1.1 Basement Floor Plan Zones 2-5 - Demolition drawings

The following drawings show the amended extent of demolition at Basement Level Zones 2-5 Gridlines W1-W26 of The Western Range Building:

Job Title
 King's Cross Station
 Redevelopment Programme
 Package 6

Scale at A1 1:100
 CCMS No
 Drawing Status
For Construction
 OAP Job No 123345-00 Drawing No WRB-CAP-0026 Rev. 08

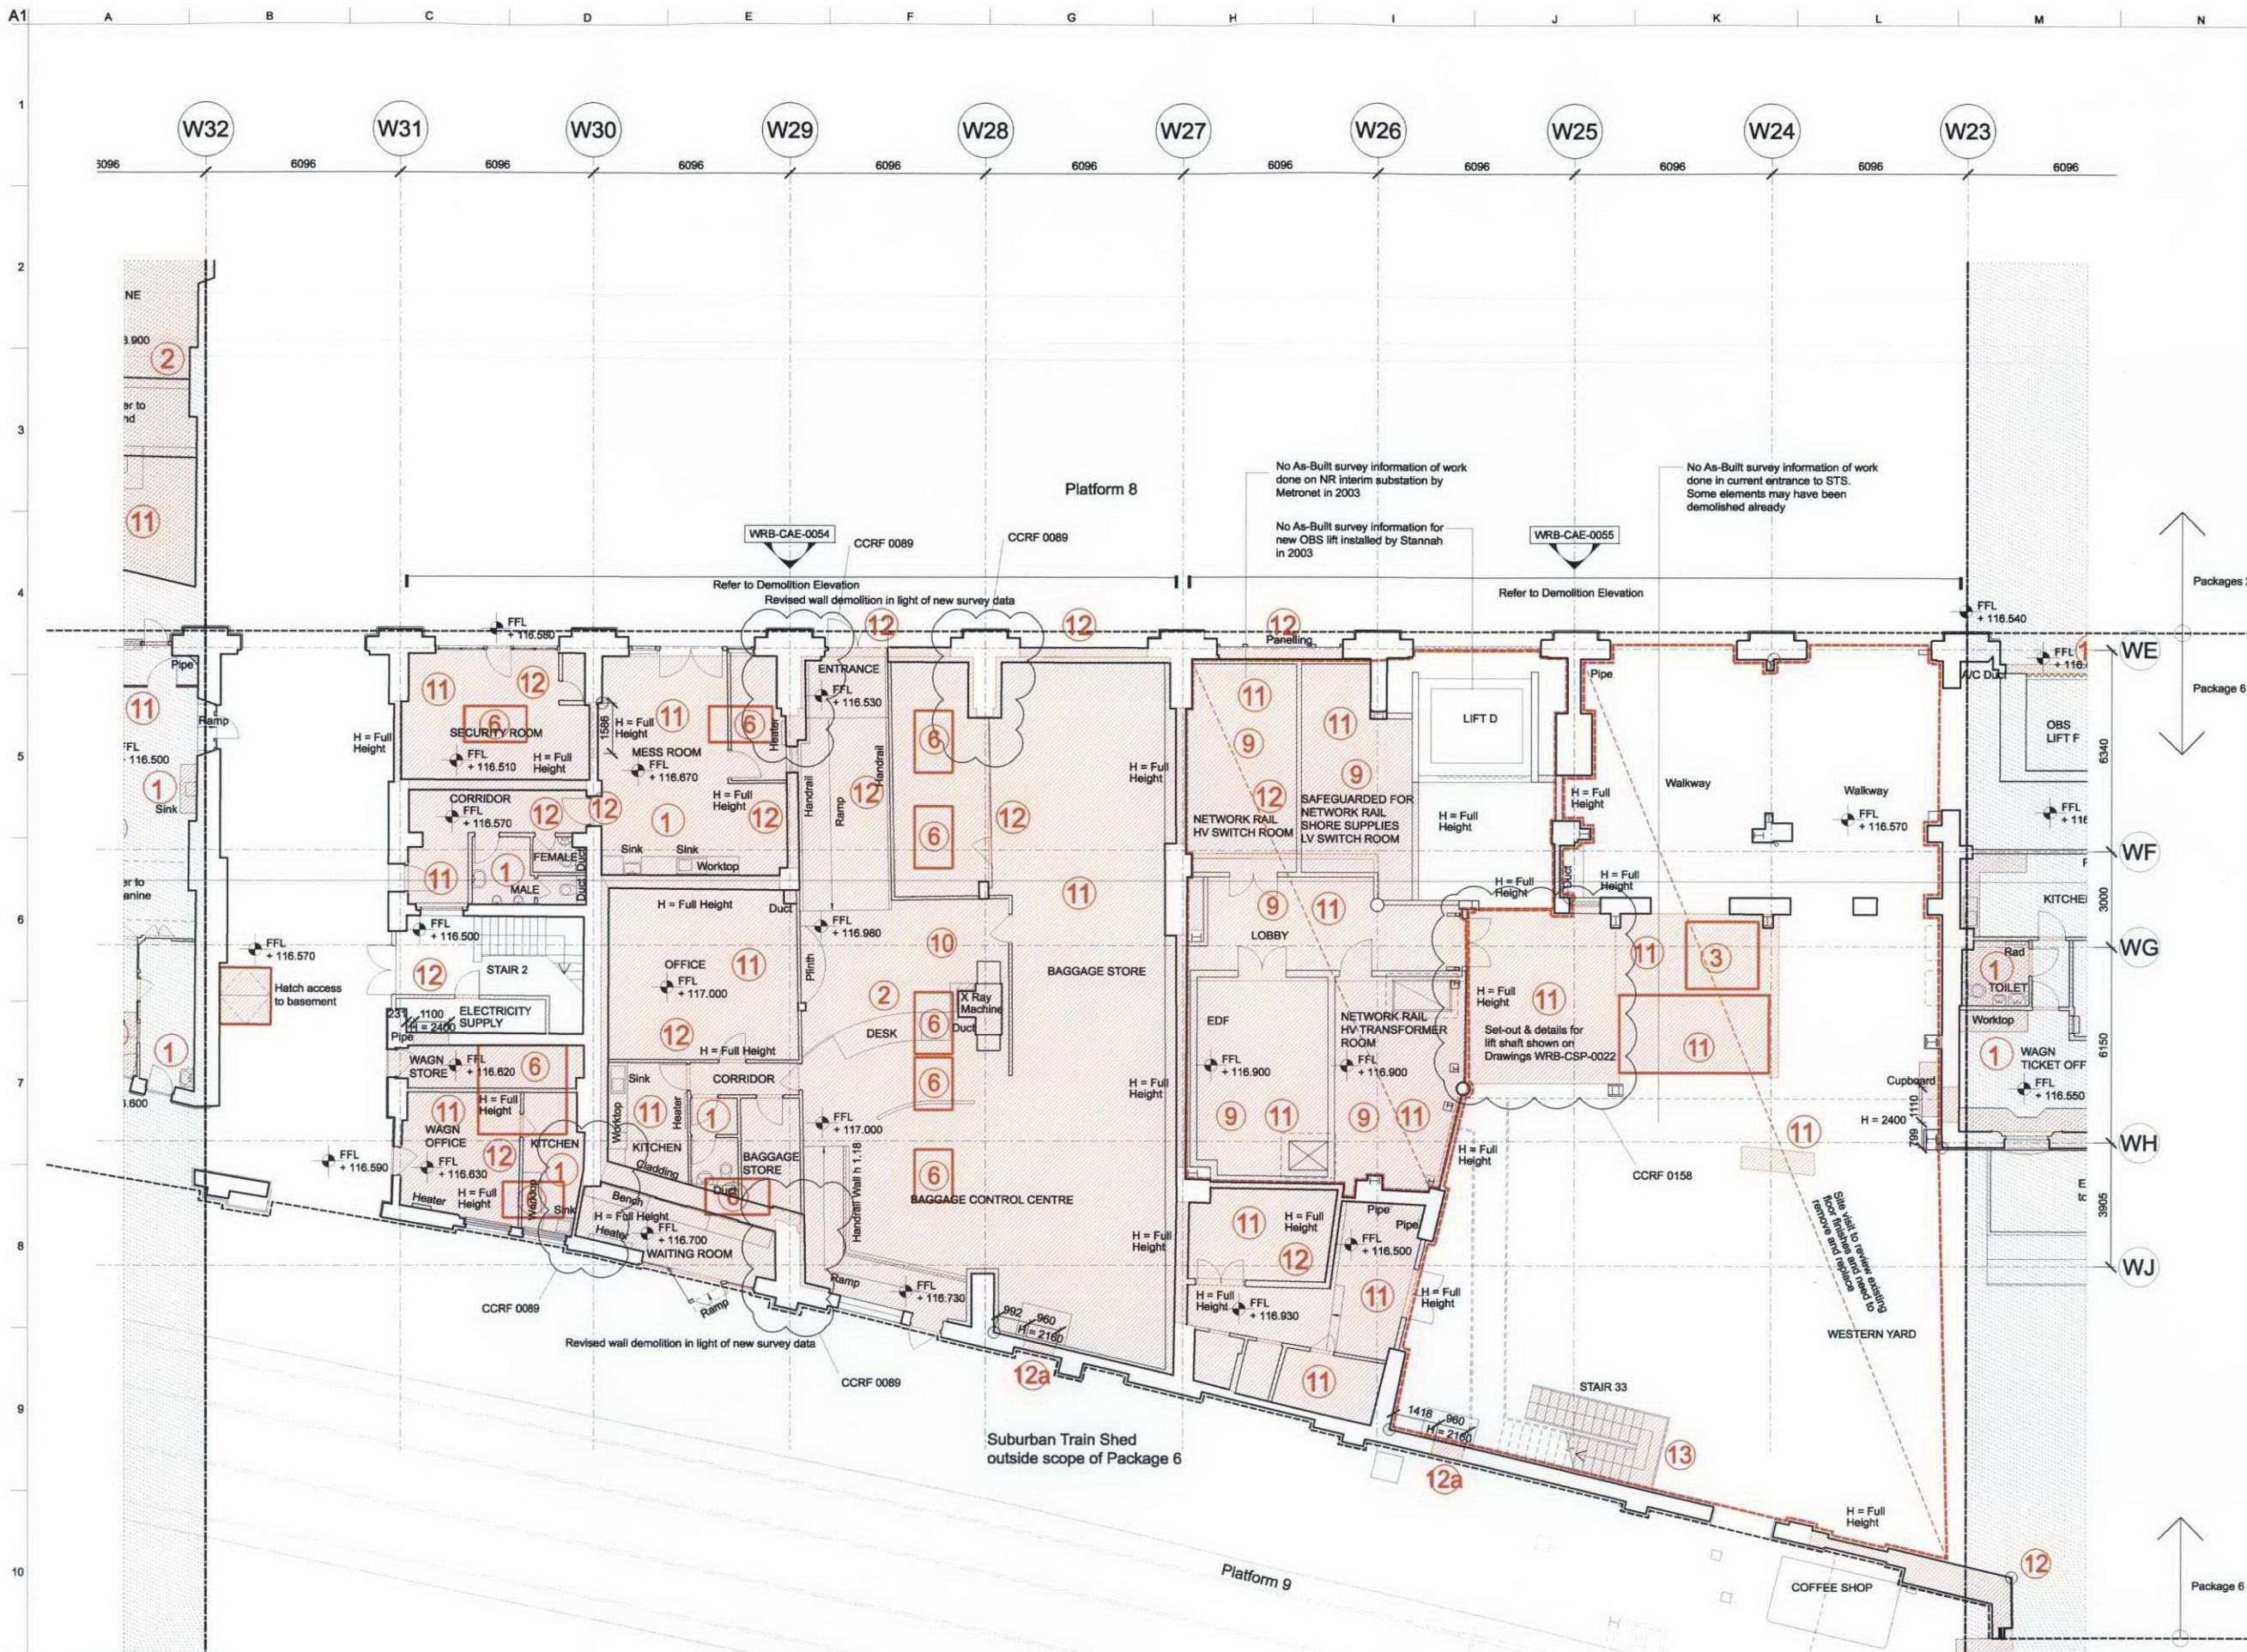
08	23/04/10	JMP	FS	AD
Revised in relation to CCRF 0089, 0158.				
07	07/08/09	JMP	GM	AD
Updated in accordance with workshop review records KX6P-PAW-SH-0027 & KX6P-PAW-SH-00023				
06	15/05/09	JMP	GM	AD
Post Value Management coordination issue				
05	30/03/09	GM	KM	AD
CTQ-00546 floor slabs demolished. Pier between Grids W23 & W24 not demolished. New door on Grid W31 not required.				
04	31/01/09	JMP	SS	AD
Revised in accordance with GRIP 6 value management redesign scope				
03	29/02/08	JMP	AD	MC
For GRIP 5B Production Information

OAP Job No	Drawing No	Rev
123345-00	WRB-CAP-0031	06

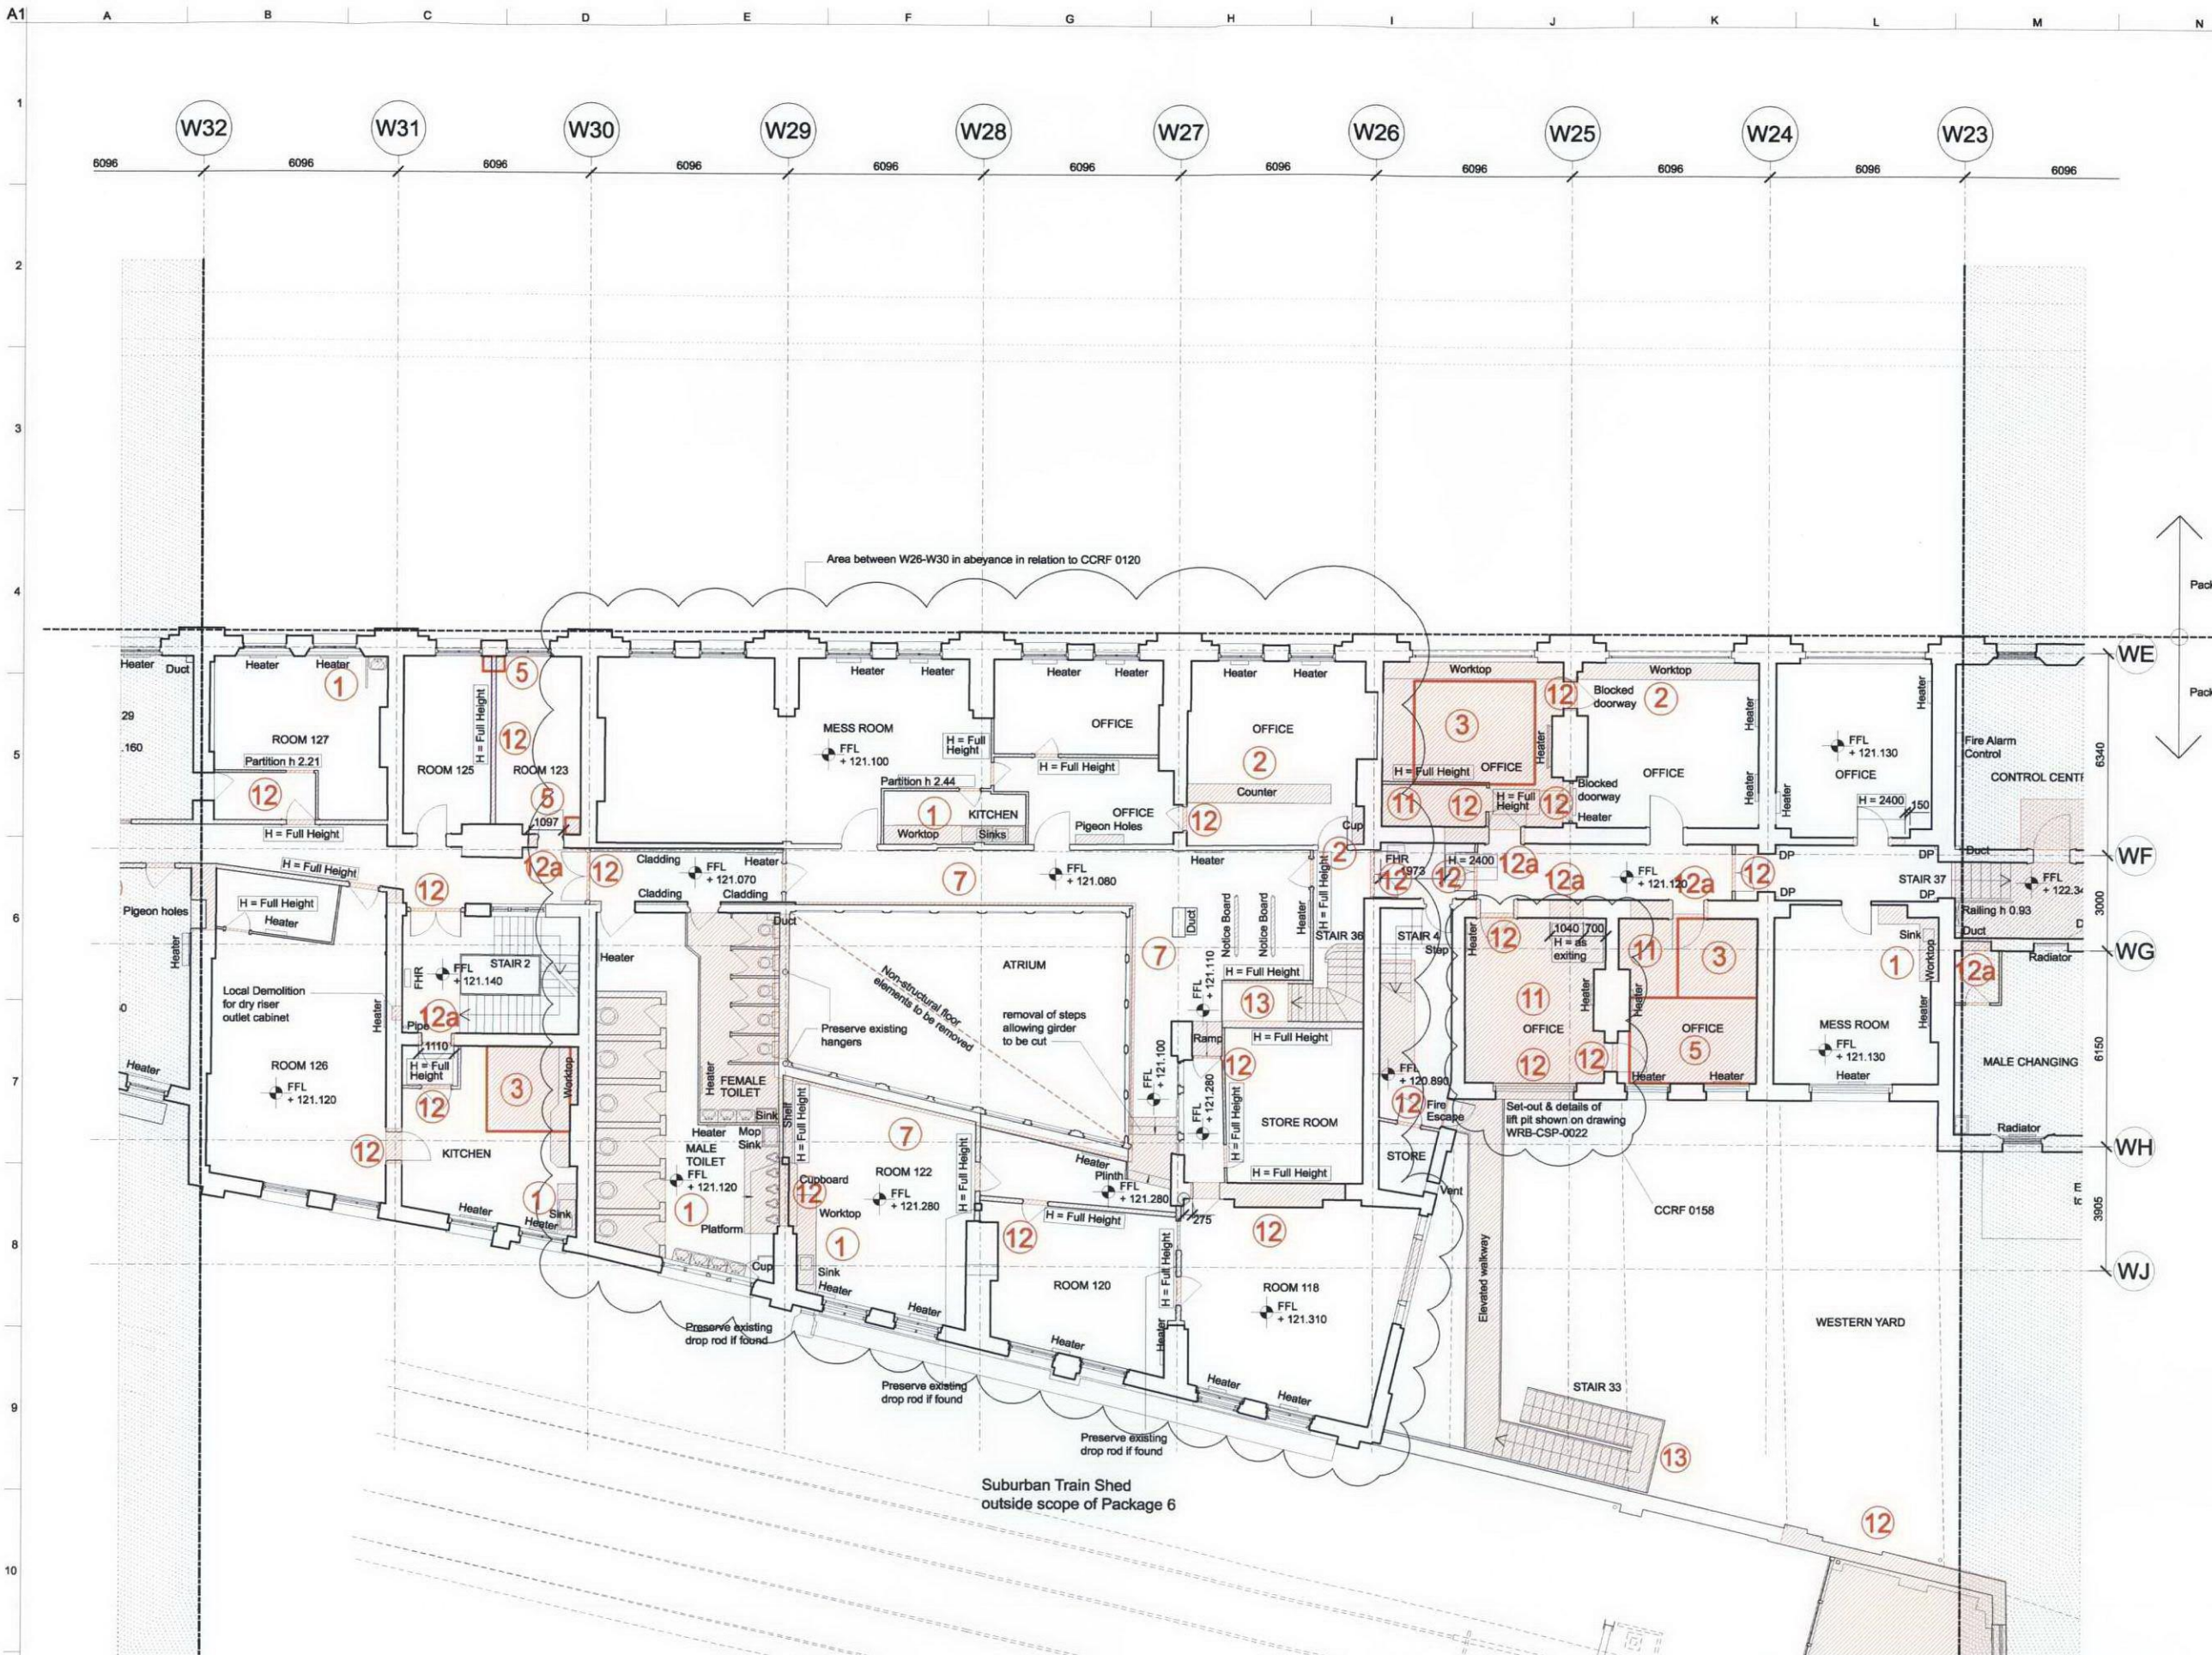
Issue	Date	By	Chkd	Appd
06	23/04/10	JMP	FS	AD
Revised in relation to CCRF 0158 and 0120				
05	07/08/09	JMP	GM	AD
Updated in accordance with workshop review records KX6P-PAW-SH-0027 & KX6P-PAW-SH-000023				
04	15/05/09	JMP	GM	AD
Post Value Management coordination issue				
03	31/01/09	JMP	SS	AD
Revised in accordance with GRIP 6 Value management redesign scope				
02	29/02/08	JMP	AD	MC
For GRIP 5B Production Information				
01	07/12/07	GM	SS	MC
Issued for GRIP Stage 5A
